TOWN OF WINCHESTER
PLANNING BOARD MEETING
TUESDAY, FEBRUARY 11, 2020 @7:30PM
SELECT BOARD ROOM

OFF HIGHLAND AVE/ABBY ROAD SUBDIVISION

TO: Winchester Planning Board
FROM: Beth Rudolph, PE, Town Engineer *BER*
DATE: February 6, 2020
RE: Abby Road Subdivision – Request for Release of Lots

B CATCH BASIN
 NOT TO SCALE

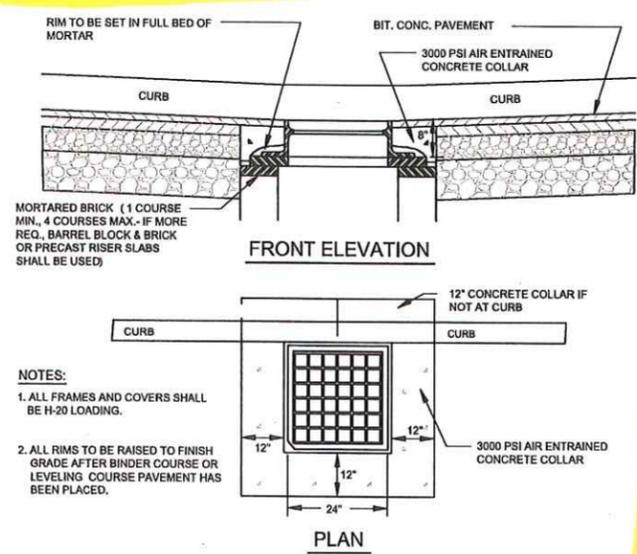
- (7) Catchbasins – The approved subdivision plans called for the installation of four double-grate catchbasins in the right-of-way. The catchbasin details were shown on Sheet D-1 of the approved subdivision plans (see Attachment 3). These details show that the catchbasin grate was to have square openings and be installed directly against the curbing to prevent runoff from flowing around the basin. The detail also notes that the catchbasins grates shall be three-flanged. There are several issues with the catchbasins, as installed:

- b. At least two of the catchbasins are four-flanged, not three-flanged as called out in the approved subdivision plans. These basins shall be replaced in accordance with the approved plans.

Attachment 3 – Catchbasin Photos from February 4 & 5, 2020

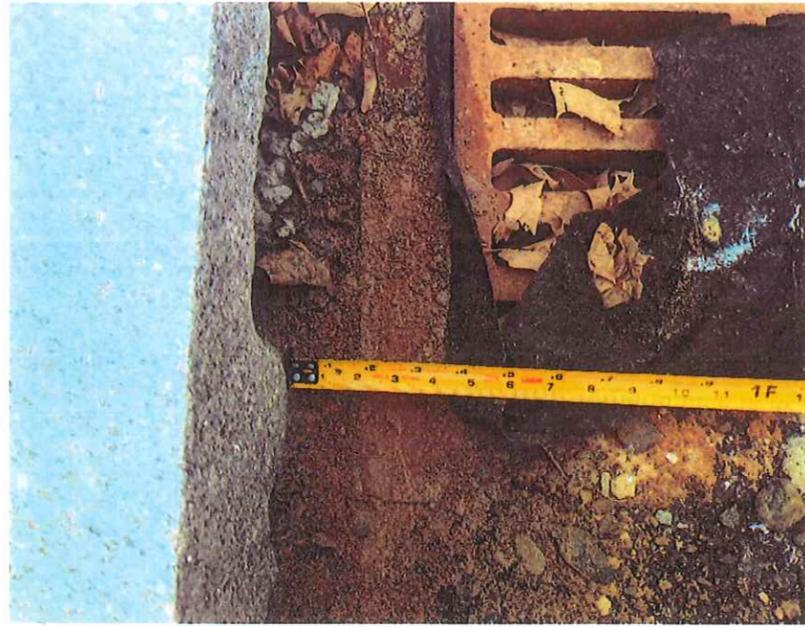
- a. Three of the catchbasins have been installed 3 to 7-inches from the curb line (see photos in Attachment 3). The fourth is in a driveway opening, so there is no curbing here. As a result, stormwater runoff can flow behind the basins and down the curblines, completely circumventing the drainage system. The catchbasins need to be reset to the curblines in accordance with the details in the approved subdivision plans. Additionally, instead of using straight curbing behind the basins, the applicant installed curb-inlet type, even though the basins are not designed to act as curb inlets. Leaves and other debris will collect in the indent in the curbing.

- c. Two of the catchbasin grates are a non-standard grate opening. The applicant shall provide calculations to show that they have the same inlet capacity as the standard, square grate, and if they do not, they should be replaced.

Attachment 4 – Sewer Manhole Photos from February 4, 2020

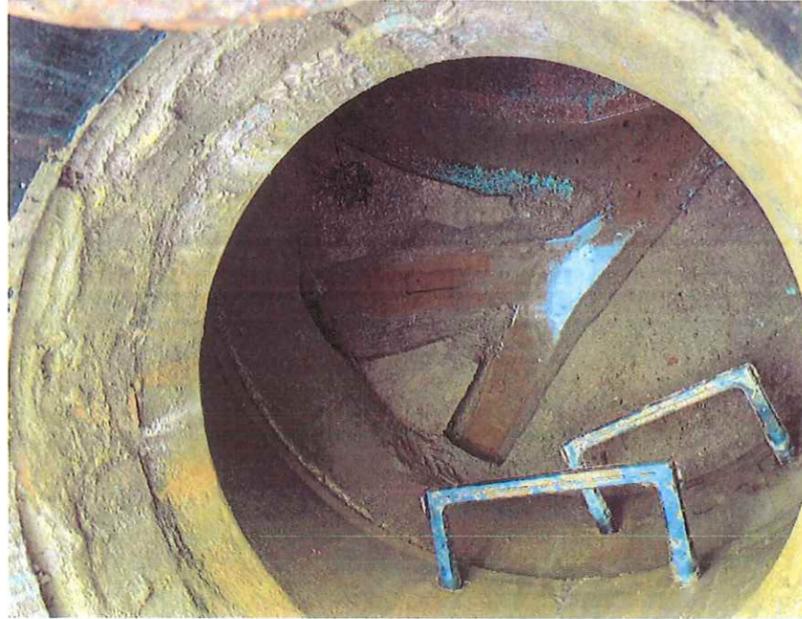
- a. Overall, the workmanship of the brick in the bottom of all the sewer manholes is poor quality, and very rough. The Engineering Department is concerned that solids and paper will get caught as sewerage flows through the manholes, causing clogging and back-ups. The inverts need to be repaired to address this concern.

- b. All of the sewer manholes currently have water pooling in them, even though there is no flow connected to the system. The Engineering Department and DPW are concerned that the bottom of the sewer manholes are not positively draining. Prior to the release of lots, the applicant should be required to survey the inlet and outlet inverts elevations at each sewer manhole to confirm that the inlet is higher than the outlet and provide a plan showing that information to the Engineering Department, and to confirm that the brick at the bottom of the manholes is positively draining towards the outlet.

- c. All of the sewer manholes have dirt and debris at the bottom of the manhole (see photos in Attachment 3), with SMH-3 being the worst. The applicant should be required to clean each sewer manhole prior to the release of any lots.

- d. SMH-4 is completely filled with water. The applicant needs to investigate what the issue is here and remedy the situation. Additionally, the rim and cover on this SMH has been knocked off and needs to be adjusted (see Attachment 4).

- e. The drop inlet connection in SMH-5 connecting the Abby Road sewer line to the pipe in Highland Avenue is not connected. Prior to the release of any lots, the applicant needs to reinstall this connection and secure it with stainless hardware to the satisfaction of the DPW.

Attachment 5 – Photos of PS#3 taken February 4, 2020

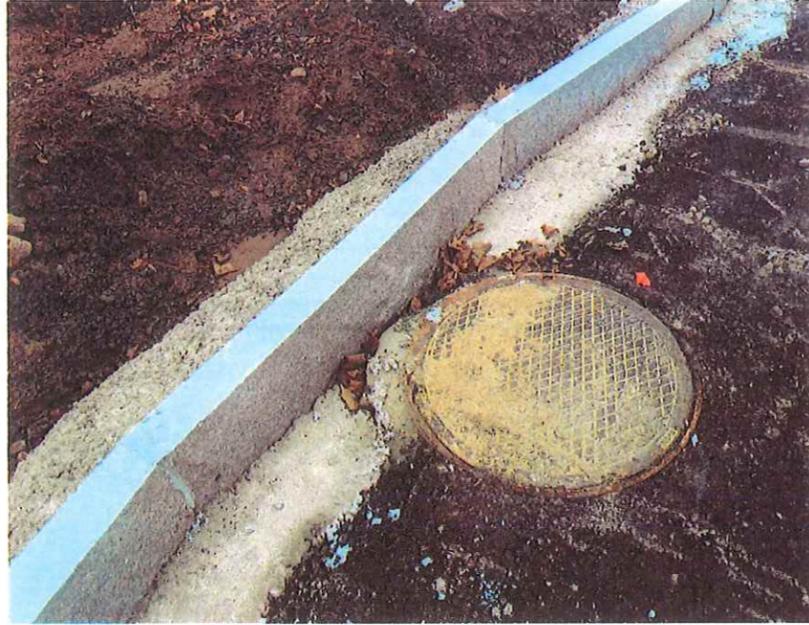
- (9) PS#3 Manhole – PS#3 shown on Sheet C-3 of the approved subdivision plans needs filled with concrete between the manhole cover and the edge of curb (see photo in Attachment 5).

- (10) Curbing at Hammerhead – The curbing at the rear of the hammerhead needs to be cut to remove the overhang at the intersection of the two pieces of curbing (see photo in Attachment 6).

Attachment 8 – Stone Bound near Station 1+50
taken February 4, 2020

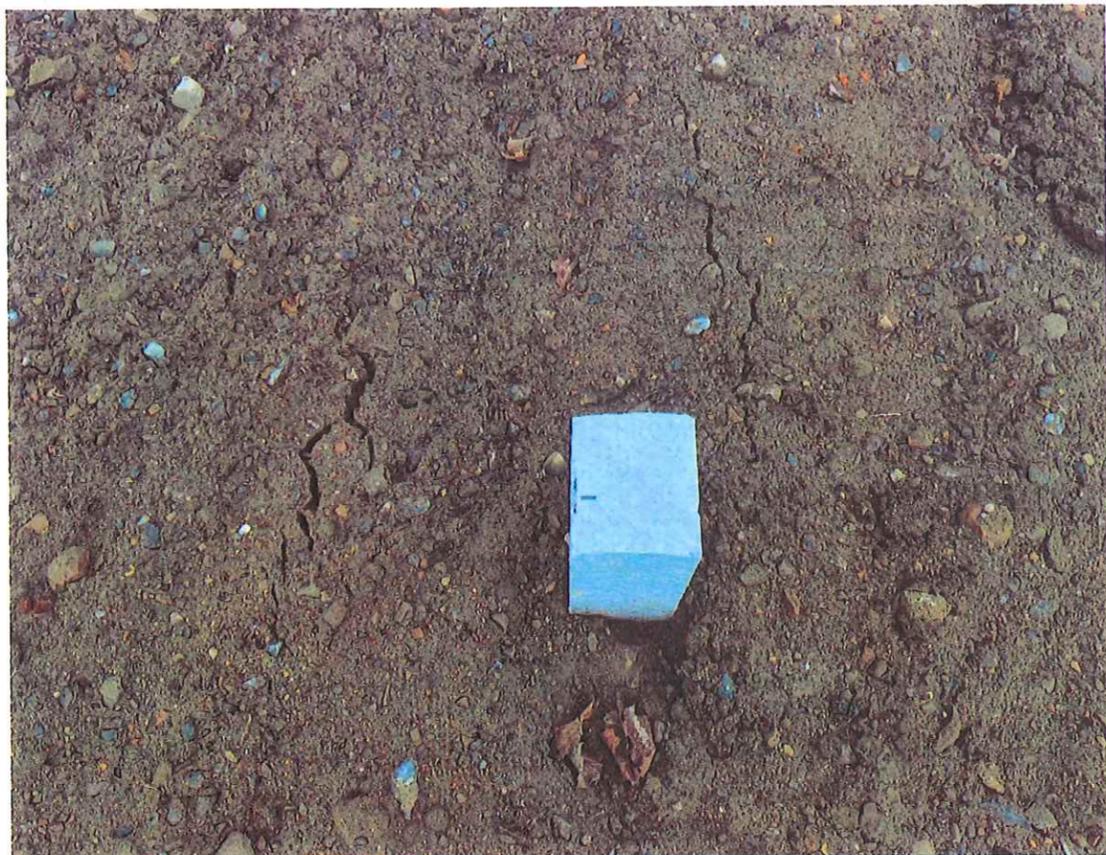
- (12) Stone Bounds – The stone bound on the south side of Abby Road near station 1+50 (see photon in Attachment 8) needs to be replaced and the drill hole redone. The current drillhole is at the edge of the bound. Other bounds should be inspected for similar issues and replaced as needed.
